LOGAN CITY COUNCIL

APPROVED PLAN OF DEVELOPMENT

MCUI/43/2016/B

DISTILLERY ROAD
124 DISTILLERY ROAD, BEENLEIGH
CLIENT - TONKEN PROPERTY GROUP

1 SITE PLAN
SCALE 1:625 @ A1
SCALE 1:1250 @ A3

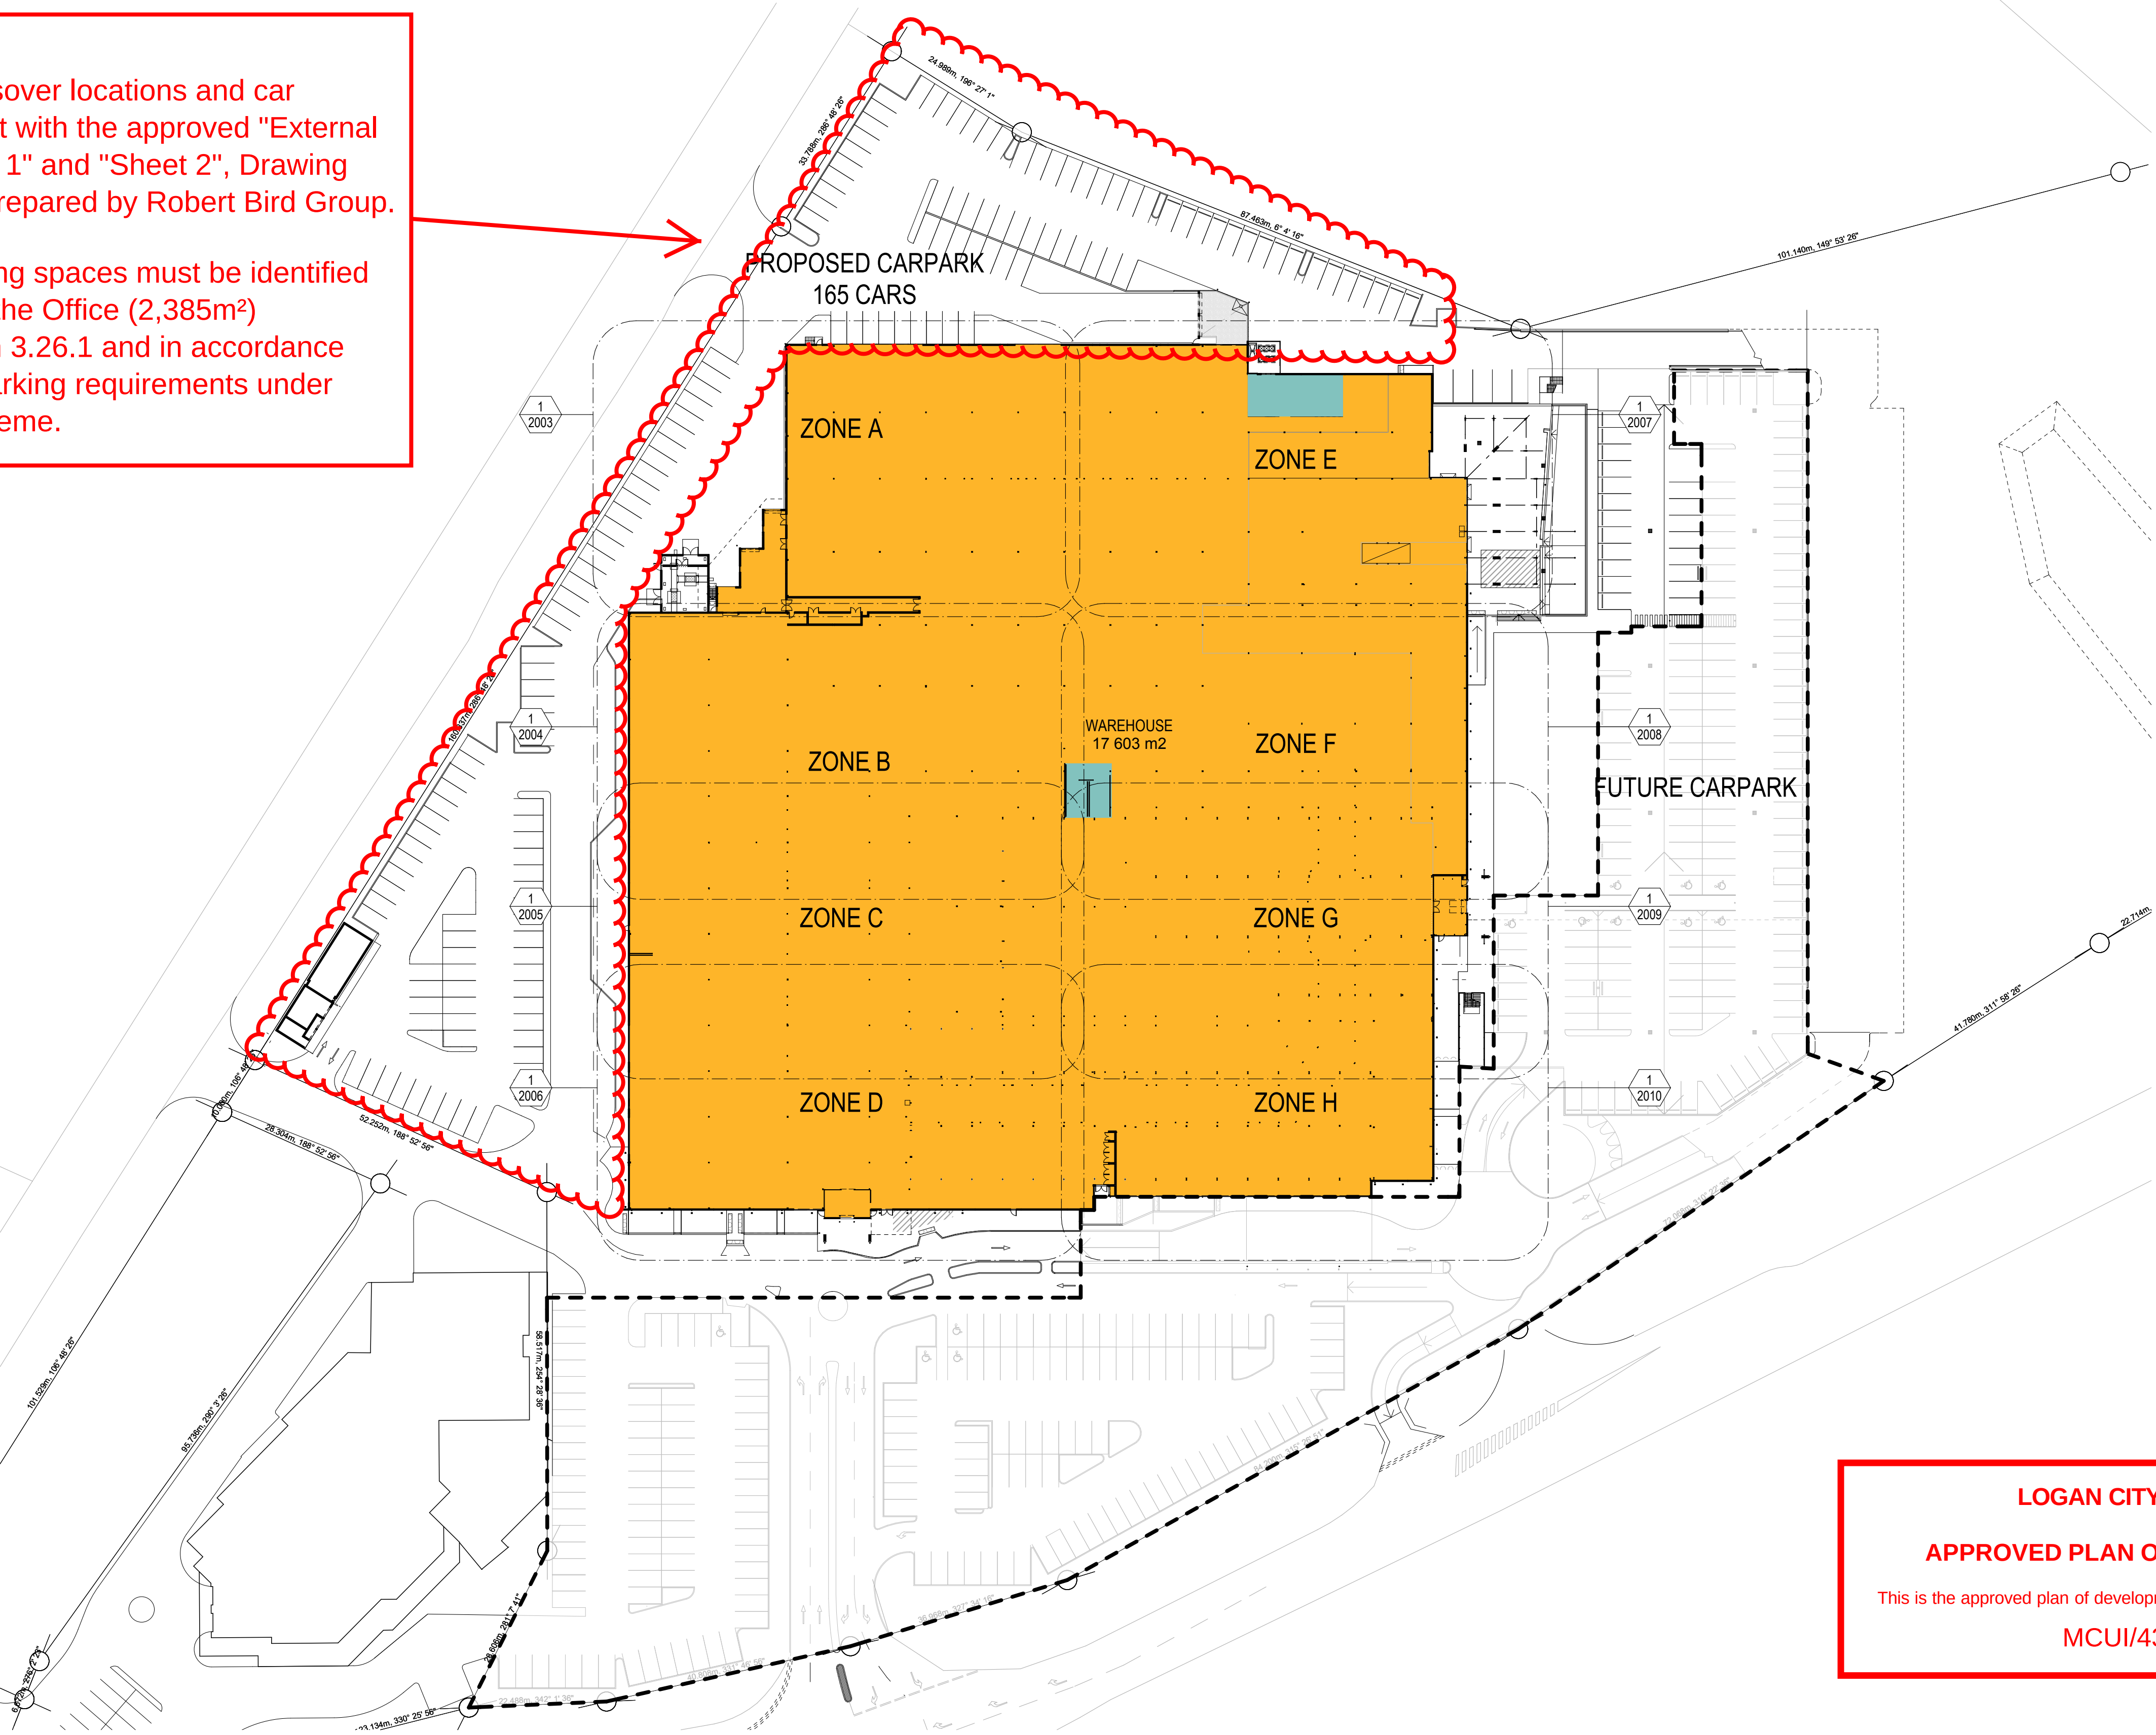
COUNCIL NOTE:
Amend the vehicle crossover locations and car parking layout consistent with the approved "External Roadworks Plans Sheet 1" and "Sheet 2", Drawing No. C9-01 and C9-02, prepared by Robert Bird Group.

A minimum 24 car parking spaces must be identified for the exclusive use of the Office (2,385m²) as required by Condition 3.26.1 and in accordance with the minimum car parking requirements under the Logan Planning Scheme.

1
-
GROUND FLOOR- ZONE A
SCALE 1:100 @ A1
SCALE 1:200 @ A3

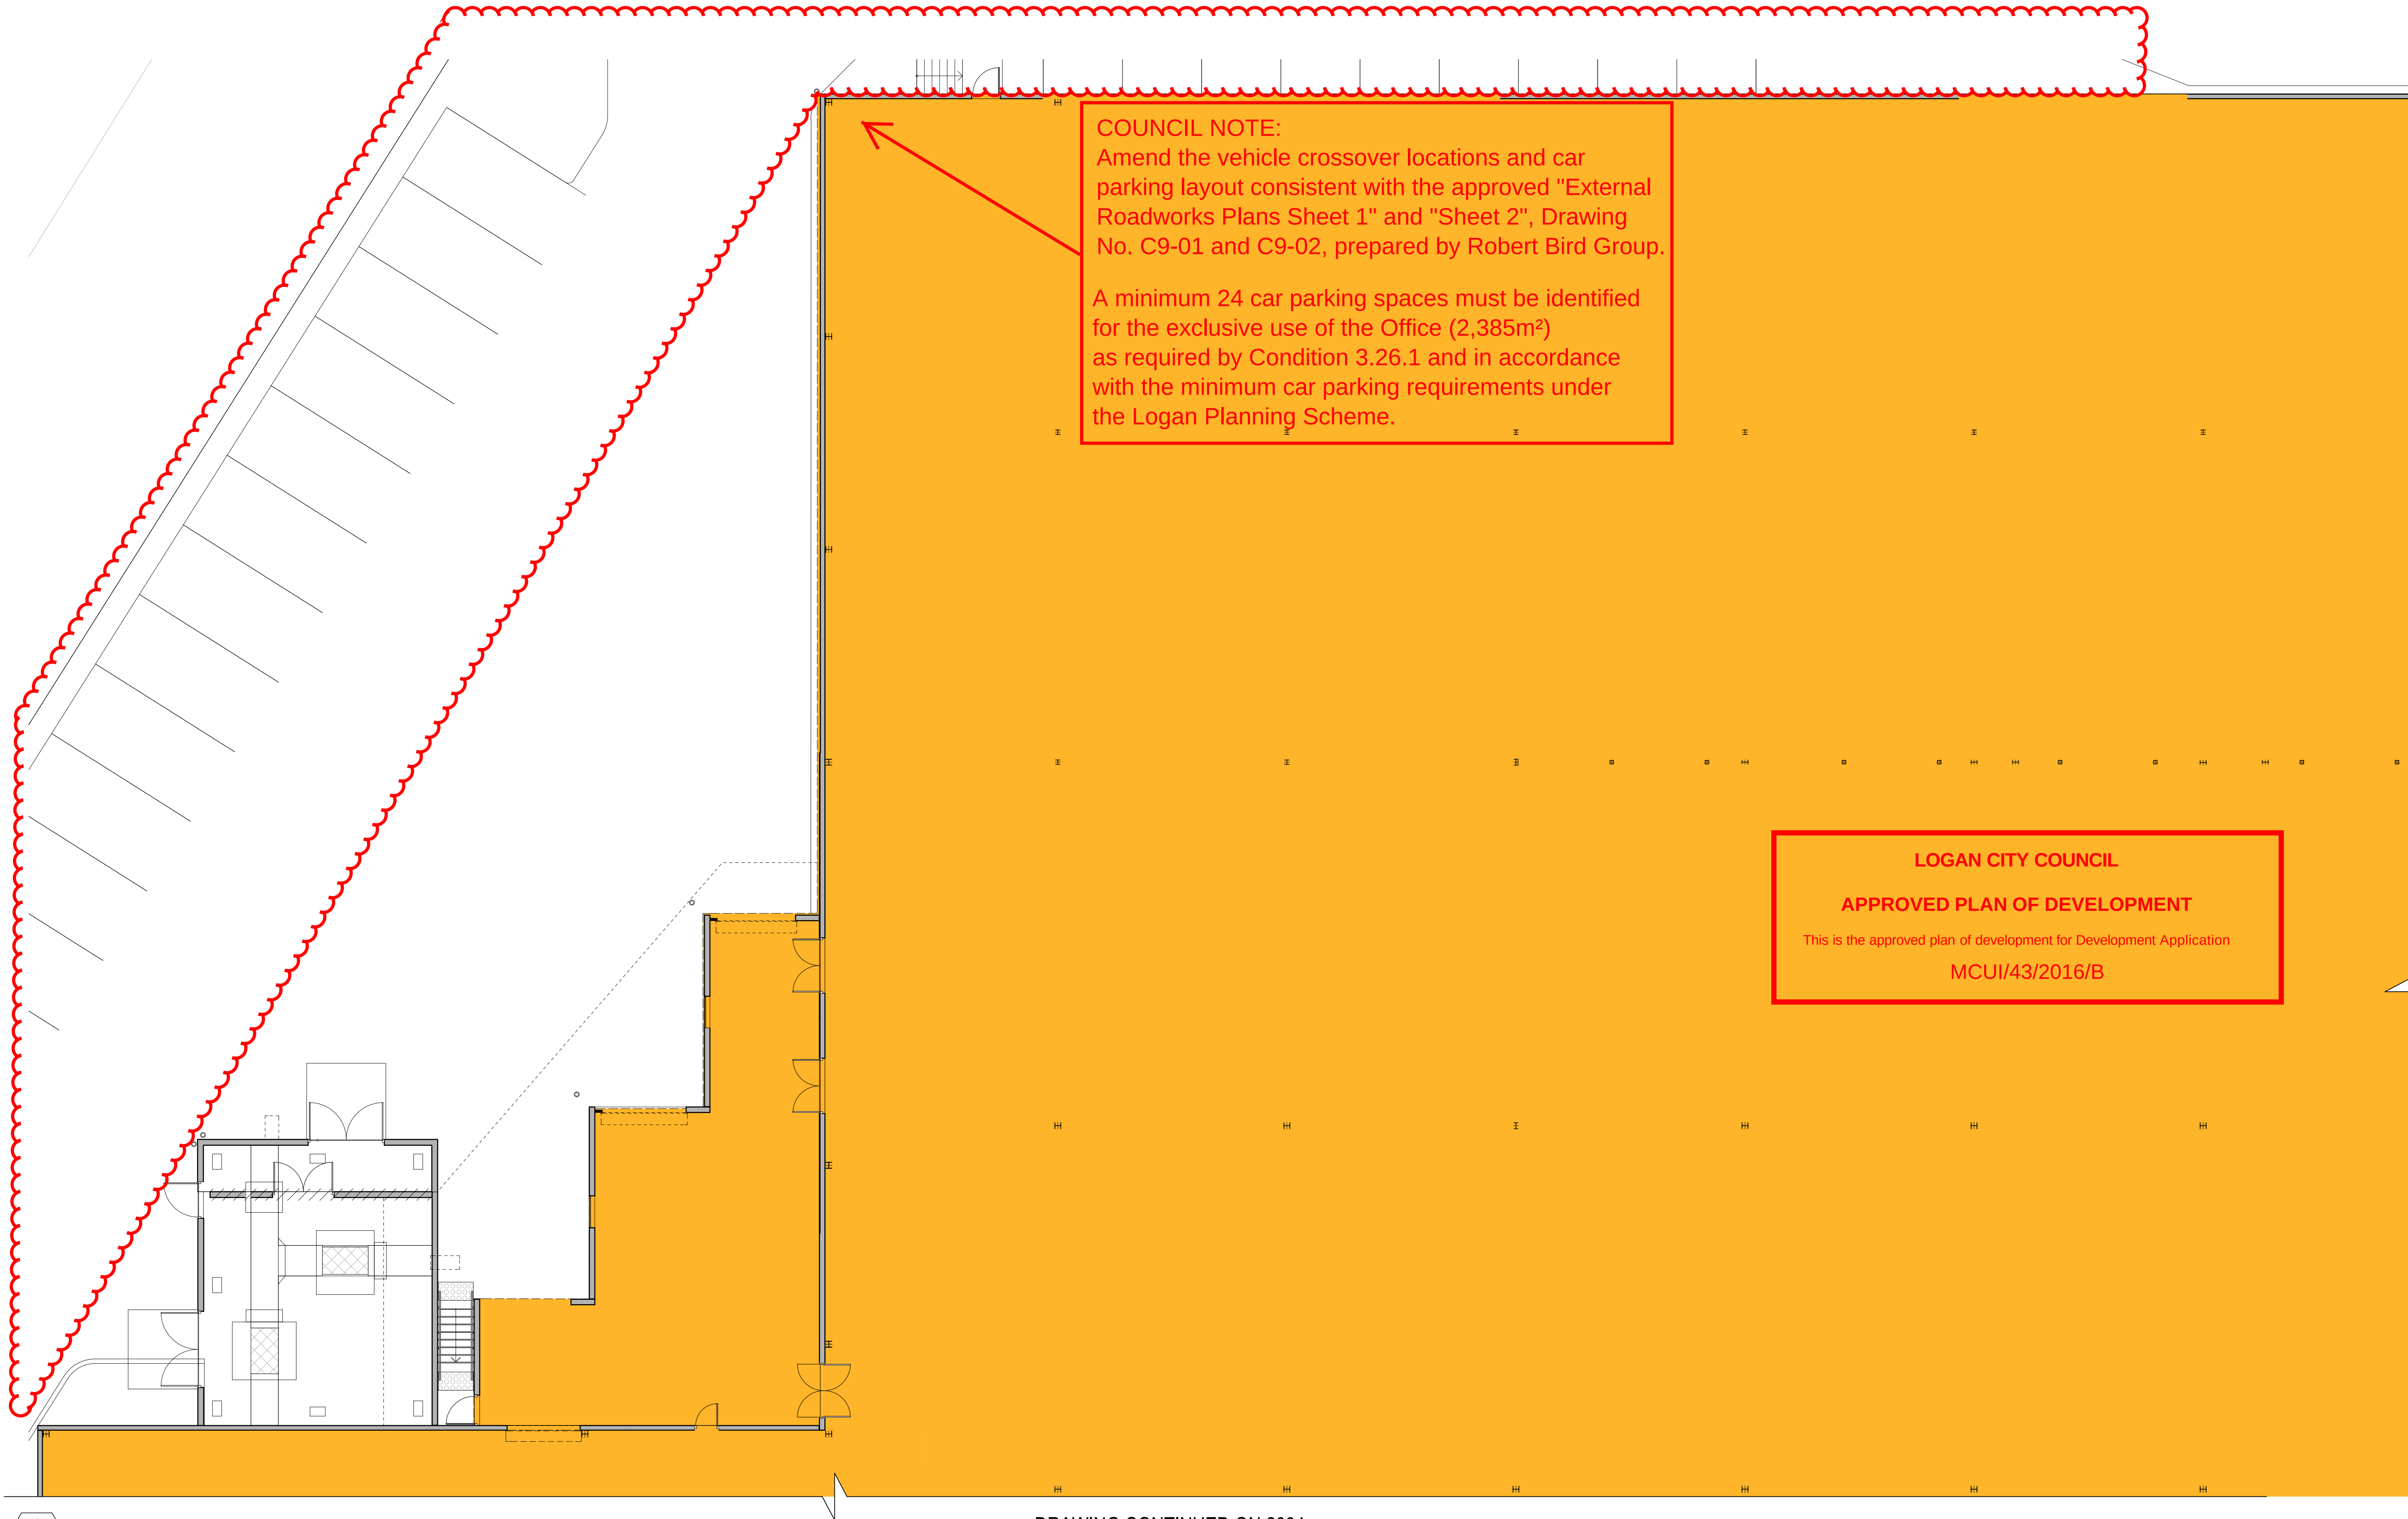
COUNCIL NOTE:
Amend the vehicle crossover locations and car parking layout consistent with the approved "External Roadworks Plans Sheet 1" and "Sheet 2", Drawing No. C9-01 and C9-02, prepared by Robert Bird Group.

A minimum 24 car parking spaces must be identified for the exclusive use of the Office (2,385m²) as required by Condition 3.26.1 and in accordance with the minimum car parking requirements under the Logan Planning Scheme.

1
-
GROUND FLOOR- ZONE G
SCALE 1:100 @ A1
SCALE 1:200 @ A3

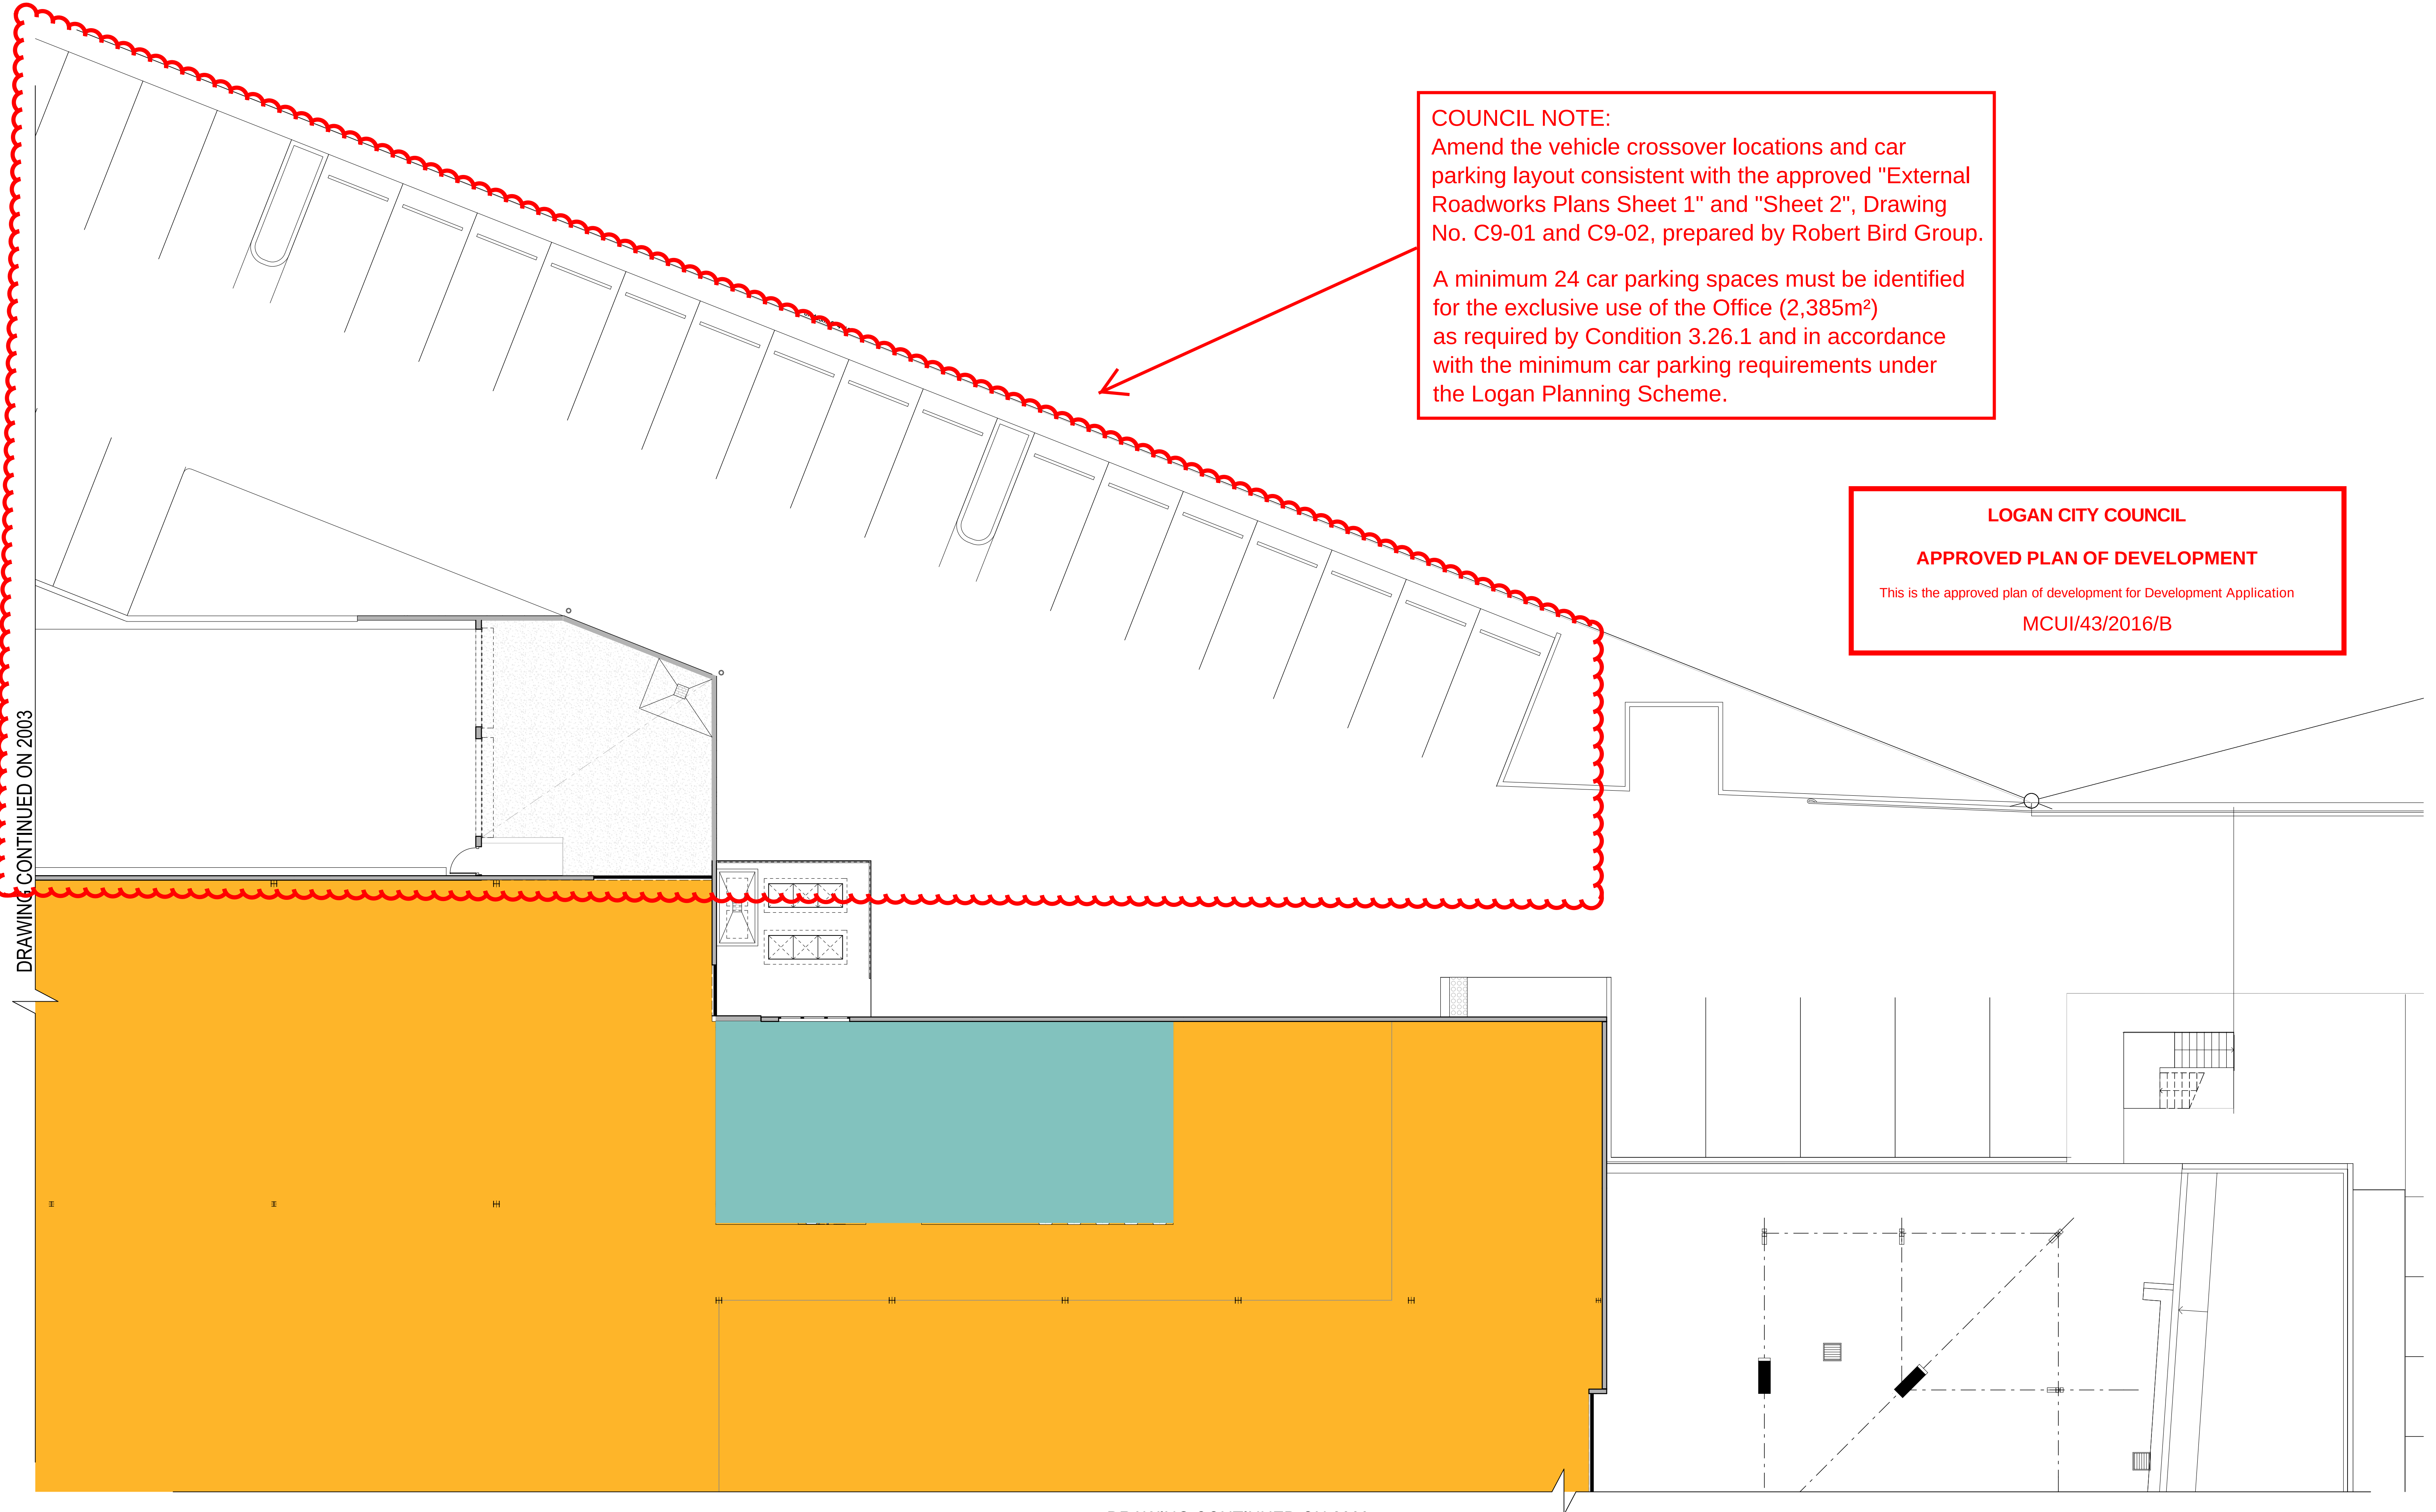
COUNCIL NOTE:
Amend the vehicle crossover locations and car parking layout consistent with the approved "External Roadworks Plans Sheet 1" and "Sheet 2", Drawing No. C9-01 and C9-02, prepared by Robert Bird Group.

A minimum 24 car parking spaces must be identified for the exclusive use of the Office (2,385m²) as required by Condition 3.26.1 and in accordance with the minimum car parking requirements under the Logan Planning Scheme.
